## V2500-A1 PROPULSION SYSTEMS SERVICE BULLETIN

This document transmits the Revision 1 of Service Bulletin V2500-ENG-72-0404.

**V2500-ENG-72-0404**  
Transmittal - Page 1 of 1

ENGINE – HP COMPRESSOR SHAFT – INTRODUCTION OF REVISED HP COMPRESSOR REARSHAFT  
ASSEMBLY WITH NO.4 BEARING LOCATION COATING (A1 MODEL)

Rework of HP compressor rear shaft  
Fig 1

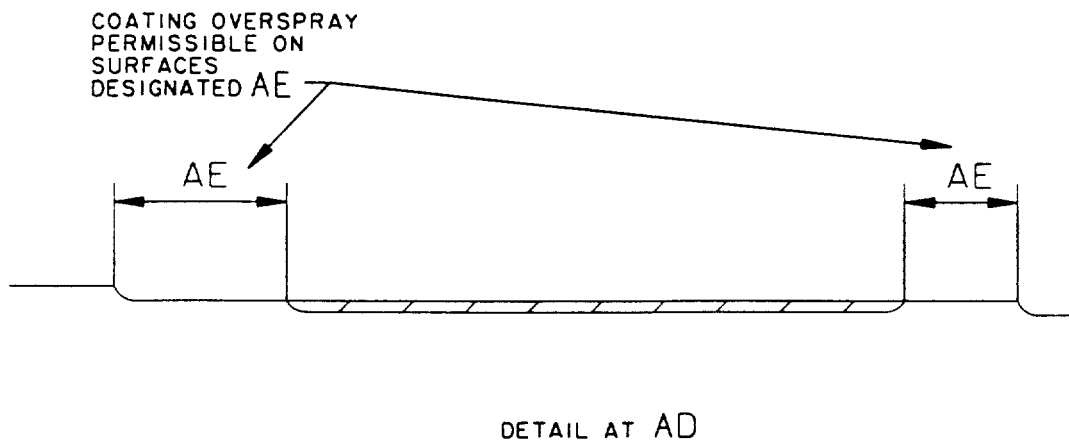
- (1) This Service Bulletin introduces an anti-fretage coating to the No.4 bearing location diameter of the HP compressor rear shaft assembly in order to minimise fretage and eliminate loss of fit between these two components.

- (a) A recess is machined into the diameter of the shaft at the No.4 bearing location to a controlled depth of 0,076mm to 0,152mm, with a width sufficient to ensure the final run-out of applied coating is well beyond the front and rear faces of the bearing.
- (b) A tungsten carbide cobalt coating is applied to the recess and machine ground back in order to maintain the current No.4 bearing location diameter.
- (2) Existing HP compressor rear shaft assemblies may only be reworked providing that the No.4 Bearing diameter (identified as ZONE AB) has not been repaired with Chromium Plate in accordance with repair VRS6509 – see Figs 1 and 2.
- (3) For effect on declared life see Time Limits Manual 5-10-01.

| <p>(b) Install the HP compressor rear shaft assembly on to the fixture and set to turn correctly</p> | <p>Refer to Fig 1 and Fig 2. Use a dial test indicator and standard workshop equipment. Make sure that datums A, B and C are set to turn correctly</p>                                 |
| <p>(c) Grind the HP compressor rear shaft assembly</p>   | <p>Refer to Fig 1 and Fig 2. Refer to approved vendor process</p>  |

| <p>(10) Cold ferric chloride etch surface AB on the HP compressor rear shaft</p>          | <p>Refer to Fig 1 and Fig 2. Refer to SPM TASK 70-11-39-300-503, SUBTASK 70-11-39-300-001. Use chemical cleaning equipment</p>   |
| <p>(11) Visually examine surface AB on the HP compressor rear shaft</p>                   | <p>Refer to Fig 1 and Fig 2. Use X10 binoculars. Indications of defects are not permitted</p>  |
| <p>(12) Do a local penetrant crack test on surface AB of the HP compressor rear shaft</p> | <p>Refer to Fig 1 and Fig 2. Refer to SPM TASK 70-23-05-230-501. Use CoMat 06-022 fluorescent penterant, with penetrant crack test equipment. Cracks are not permitted</p> |

| (14) Apply the metal spray hard coating to surface AB on the HP compressor rear shaft | Refer to Fig 1 and Fig 2. Refer to vendor approved process |

V2500-A1 family tree  
Fig 3

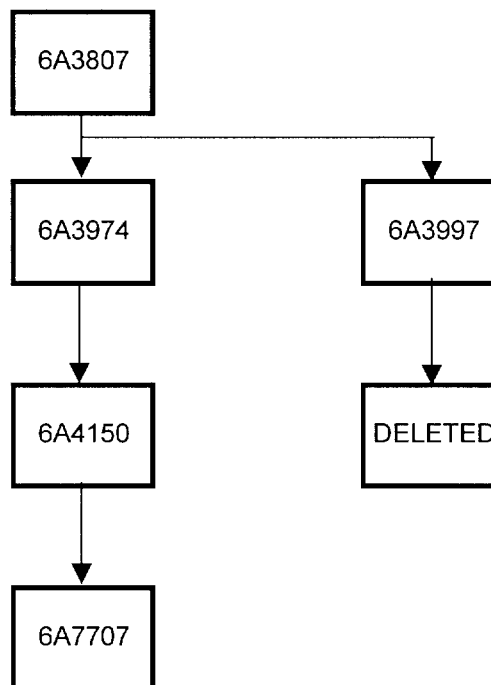
Introduction of a revised HP Comp  
rear shaft assembly with No.4  
bearing location diameter coating
